PRODUCT/PROCESS CHANGE NOTICE (PCN)

PCN #: **A1110-02** DATE: **October 17, 2011**

Product Affected: **7.6mm x 10.4mm SOIC-16**

Hana assembled part (with Pin 1 dimple)

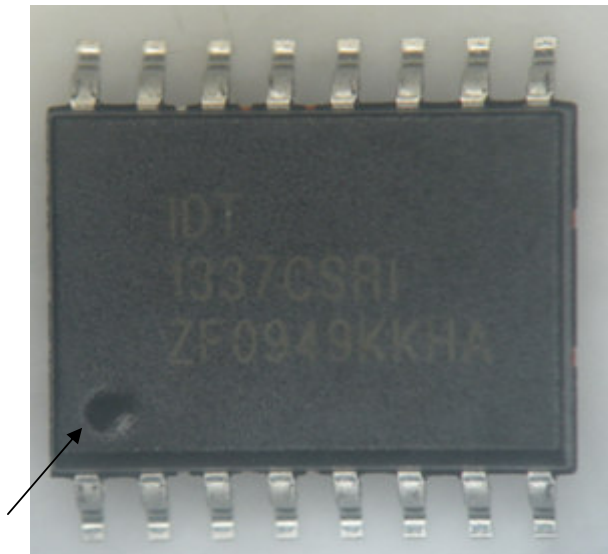
Pin 1 identification mark for products assembled at Cirtek will be a dot compare to dimple for Hana assembled parts. Please refer below for pin 1 identification mark for parts assembled at Hana and
